**Re: Minor Project Refinement No. 15 for the South Orange County Reliability Enhancement Project.**

## South Orange County Reliability Enhancement Project CPUC Minor Project Refinement Form

**ATTACHMENT B**  
**MPR-15 Figure**

**SOCRE PROJECT**  
**MPR-15 Z100153**  
**San Clemente**  
**Orange County, CA**

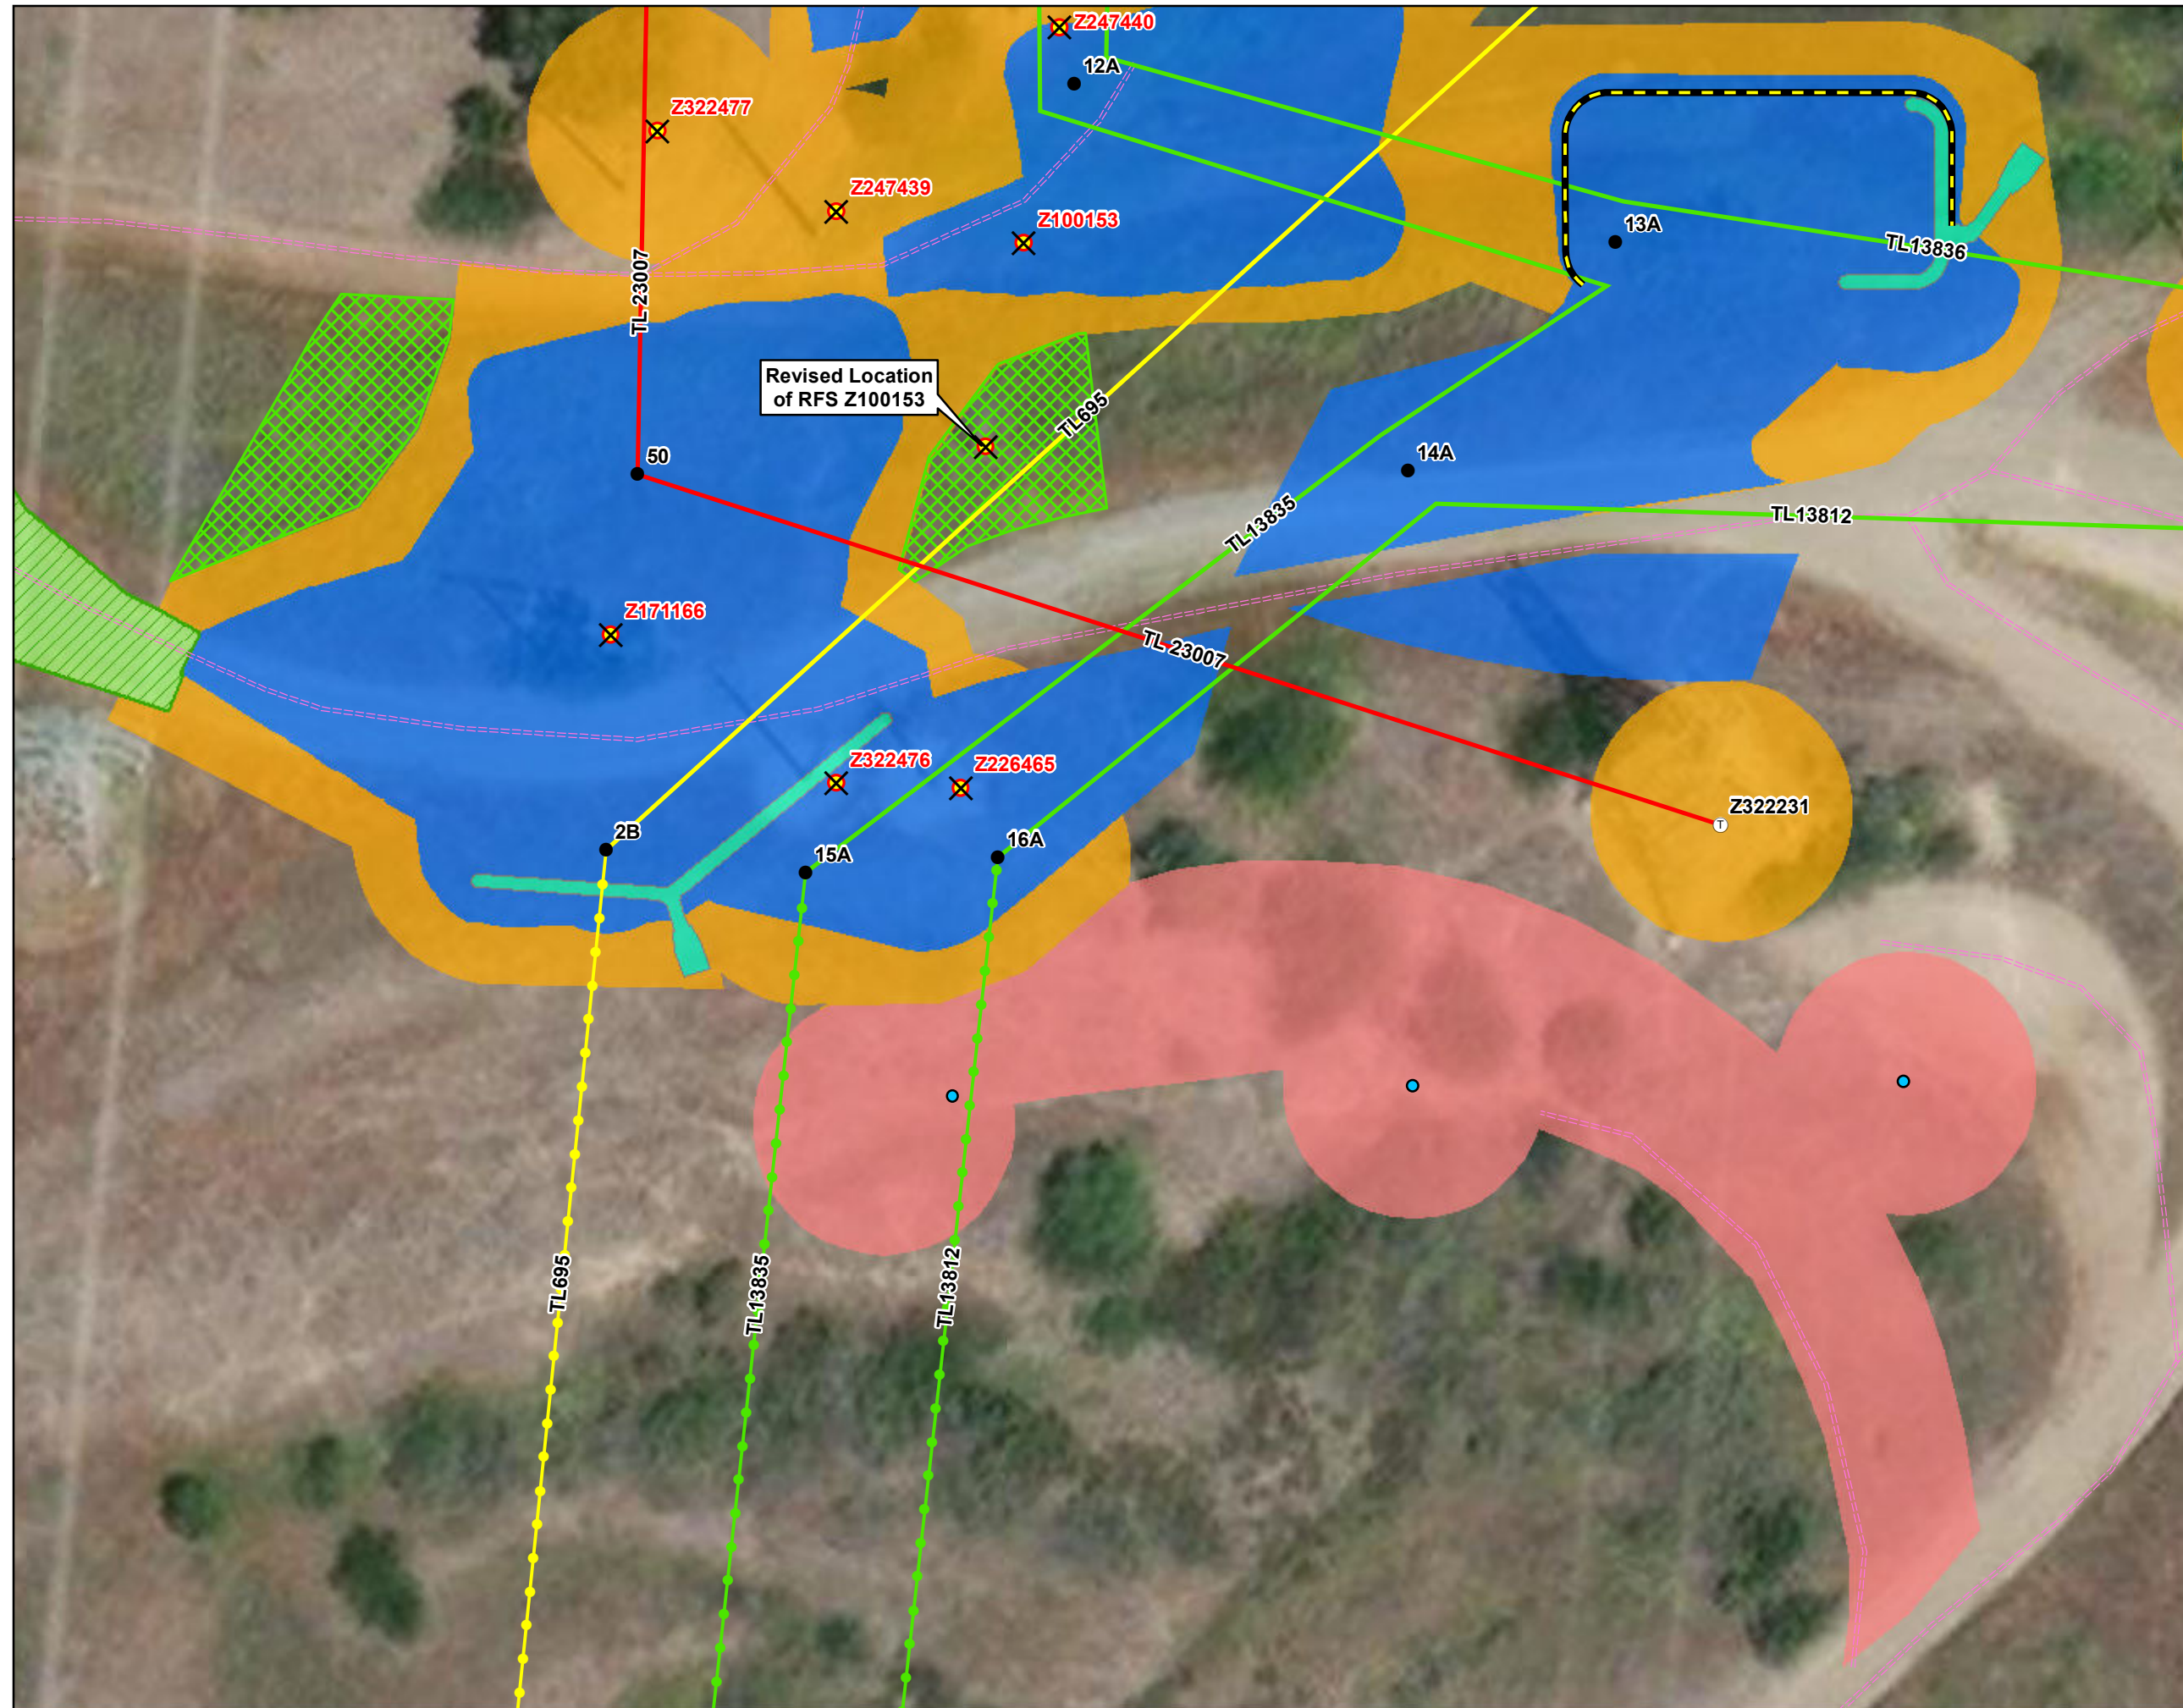
The eastern MPR-15 temporary work area is required in order to access the remove-from-service (RFS) pole Z100153. Existing RFS pole Z100153 was mapped incorrectly in the NTPR-7 Mapbook and its true position falls outside of the approved Project work areas (See **Attachment B, MPR-15 Figure**). The pole will be accessed from the east via the existing access road. The pole will be dismantled by crane and hauled away by a flatbed truck as described in Section 2.4.5.4 of the FEIR. The concrete foundation will be jackhammered and removed with an excavator. There is no ground disturbance anticipated to be required within the MPR-15 work areas with the exception of the Z100153 pole removal activities.

The construction contractor identified the need to utilize the eastern MPR-15 work area in order to access the RFS pole Z100153. RFS pole Z100153 is currently located approximately 50 feet south of its original mapped location within the 12A work area due to a mapping error. It now falls outside of the approved Project work areas (See **Attachment B, MPR-15 Figure**). Therefore, MPR-15 is proposing the use of the eastern additional work area and associated land disturbance that was not included in NTPR-7, but is necessary to construct the Project as described in Section 2.3.3.1 of the Final Environmental Impact Report (FEIR) and the REIR approved by the MCBCP. The pole will be accessed from the east via the existing access road. The pole cannot be accessed from the west (existing Location 50 work area) due to the slope and existing transmission structure down guy wires. As stated above, the western MPR-15 work area is not anticipated to be utilized by the Project, but is being included as part of the corrective action for the compliance incident on November 29, where the area was mowed.

Although the proposed MPR-15 temporary work areas total 2,925 square feet (0.07 acre), a large portion of the work area contiguous to the Location 50, 2B, 15A, and 16A work area is no longer being utilized by the Project (see **Attachment B, MPR-15 Figure**). This southern portion of work area is 14,300 square feet (0.32 acre), therefore the overall temporary disturbance acreage would not be increased by the addition of the MPR-15 work areas. The overall temporary disturbance area would be reduced by 11,375 square feet (0.26 acre) as a result.

COA-1. The extent of the MPR-15 disturbance areas will be limited to the areas shown on the figure titled "SOCRE PROJECT MPR-15 Z100153" and will be used for project construction staging and related activities only during the period of project construction and restoration (anticipated to be approximately through the end of 2024).

**Photograph 1:**  
View of the western MPR-15 work area. This area is not anticipated for Project use but is being included as part of the corrective action for the compliance incident from November 29, 2022 where this area was mowed outside of work limits.  
Facing: South

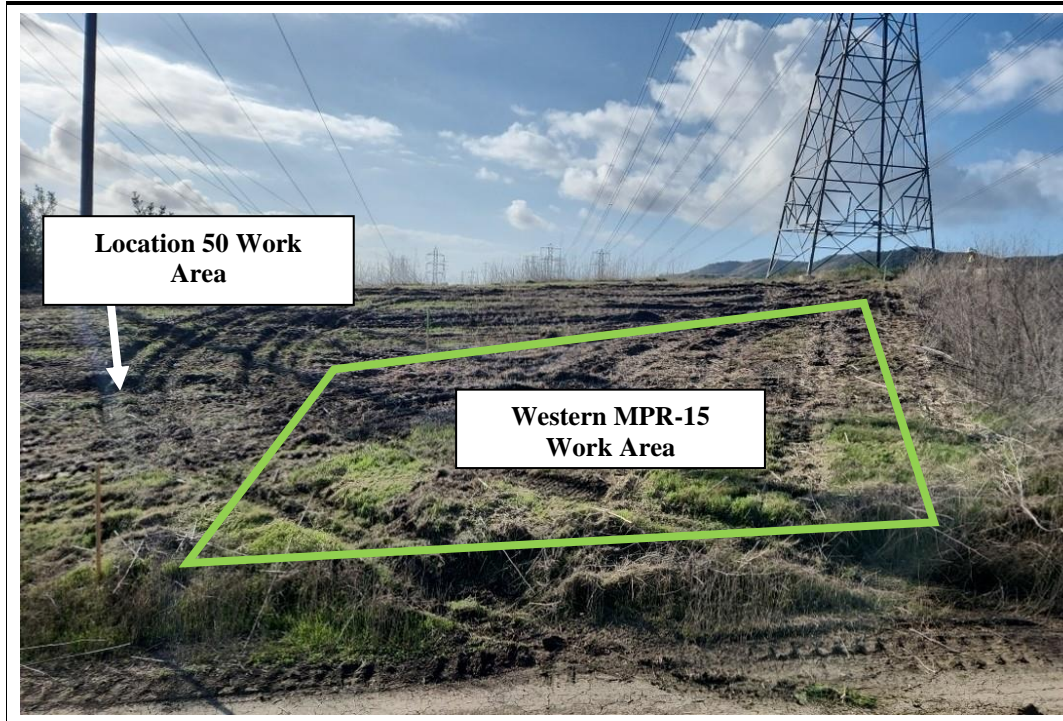
The western MPR-15 temporary work area is being included as part of the corrective action for the compliance incident that took place on November 29, 2022. The area was mowed outside of the approved work limits during vegetation trimming activities at Location 50. The Project does not currently anticipate the use of this western area, but the additional temporary impact is being recorded in MPR-15 for the Project record.
